**MINERALS PROGRAM INSPECTION REPORT**  
**PHONE: (303) 866-3567**

<b>MINE NAME:</b> Huddleson Stock Pond	<b>MINE/PROSPECTING ID#:</b> M-2019-009	<b>MINERAL:</b> Sand	<b>COUNTY:</b> El Paso
<b>INSPECTION TYPE:</b> Surety-Related Inspection	<b>INSPECTOR(S):</b> Timothy Cazier, P.E.	<b>INSP. DATE:</b> March 24, 2021	<b>INSP. TIME:</b> 11:10
<b>OPERATOR:</b> Luther E Huddleson	<b>OPERATOR REPRESENTATIVE:</b> Luther Huddleson	<b>TYPE OF OPERATION:</b> 111(1)(b) - Special One-Time Incidental	
<b>REASON FOR INSPECTION:</b> Surety Release Requested	<b>BOND CALCULATION TYPE:</b> Complete Bond	<b>BOND AMOUNT:</b> \$5,000.00	
<b>DATE OF COMPLAINT:</b> NA	<b>POST INSP. CONTACTS:</b> None	<b>JOINT INSP. AGENCY:</b> None	
<b>WEATHER:</b> Cloudy	<b>INSPECTOR'S SIGNATURE:</b> 	<b>SIGNATURE DATE:</b> April 21, 2021

Photo 6. Foothills seed mix.

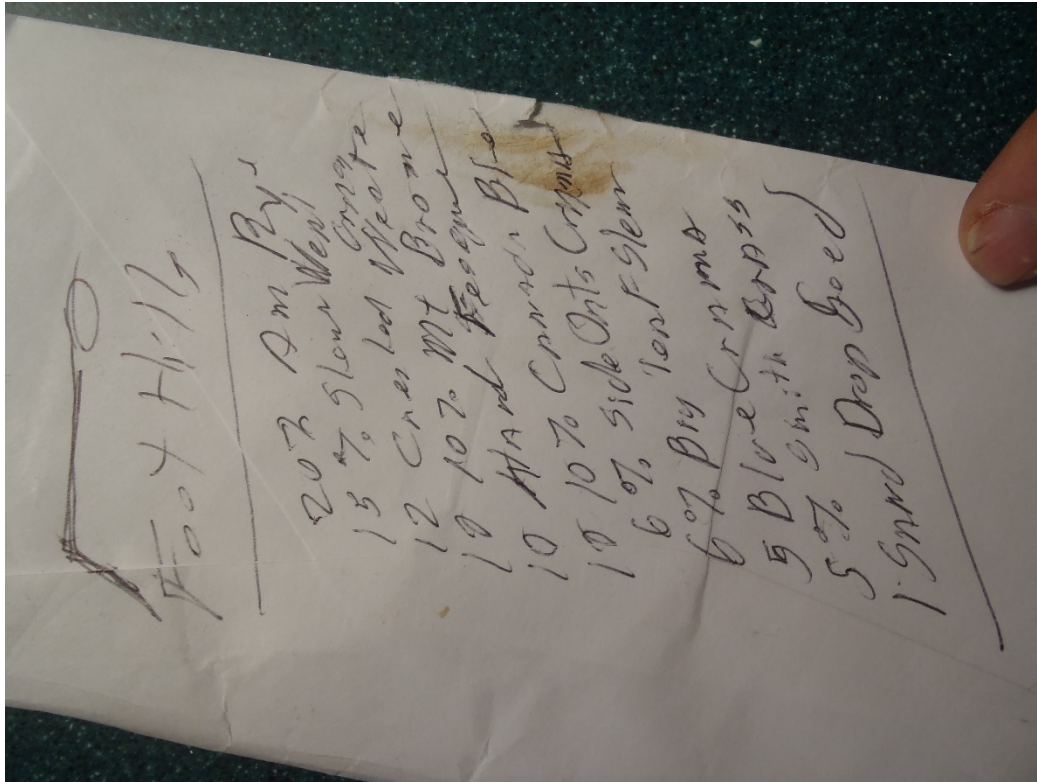
Revegetation: Mr. Huddleson stated he planned to seed the exterior slopes on April 15<sup>th</sup> with a foothills seed mix (see **Photo 6**) and agreed to provide documentation to the DRMS demonstrating he had done so. No noxious weeds were observed.
